**Errata to
Fundamentals of Steam System Design,
I-P Edition (2006)**

April 25, 2016

Figure 3.10 Capacities and dimensions of baseboard units.

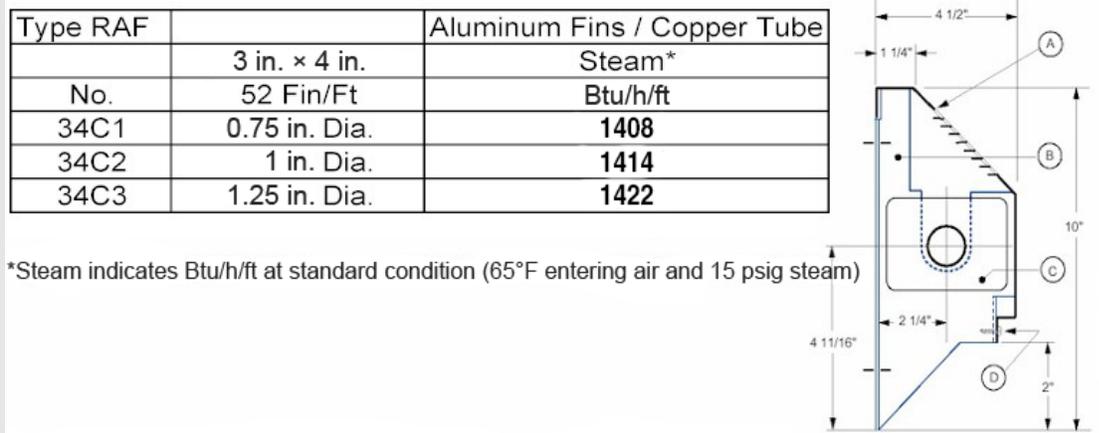
Page 3:12 Replace Figure 3.10 with the following:
[Please note that earlier errata sheets had supplied a revised Figure 3.10 with incorrect Btu/h/ft values in the table. The below Figure 3.10 has been corrected.]
